**TOWN OF WARREN
CONDITIONAL USE RESIDENTIAL
PERMIT APPLICATION**

Permit Application No. 2014-03-CU

5. Project or Development sought under **Conditional Use:** REVISE SITE PLAN & BUILDING ENVELOPE
7. Attach a narrative describing the proposed **Conditional Use** (see Articles 5).

Robert Adams and Meg Succop
939 Fuller Hill Road, Warren VT

**ATTACHMENT 2:
Altered siteplan**

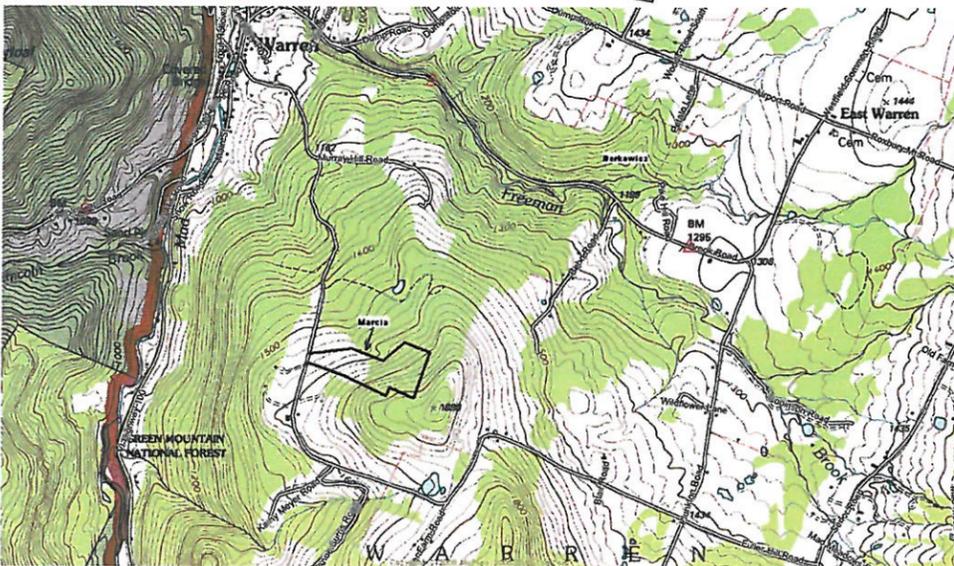
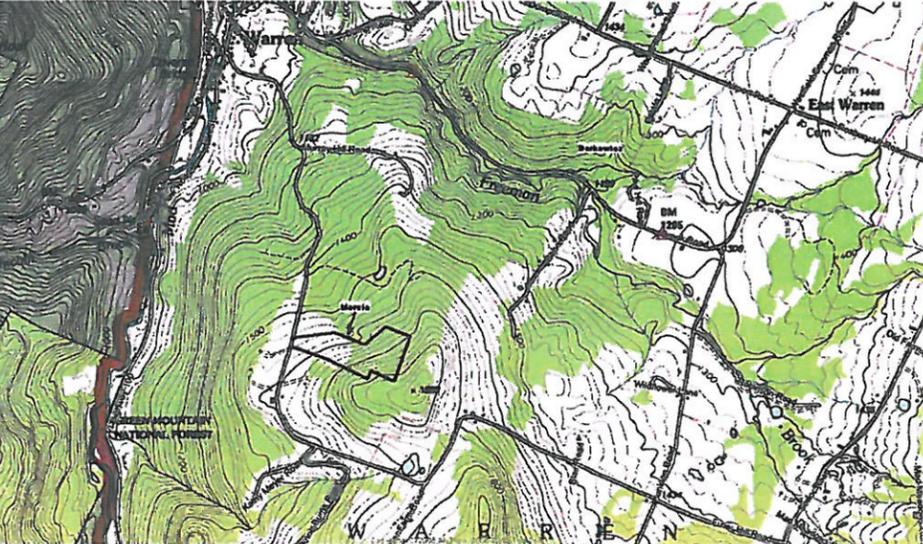
The slight alterations to the proposed plan involve 'mirroring' the house and garage and extending the driveway an additional 50'. The reasoning for the alternation is to allow the garage and house to be better sited upon the natural topography. The proposed alternation places the entrance, driveway turnaround in an area that has a more gradual slope, which allows less disruption of the landscape (earthwork and retaining walls). The 'building' site remains the same, the layout is simply mirrored. The driveway remains as previously approved but slightly lengthened to gain access to the north side of the house rather than the south. The septic and well locations remain the same.
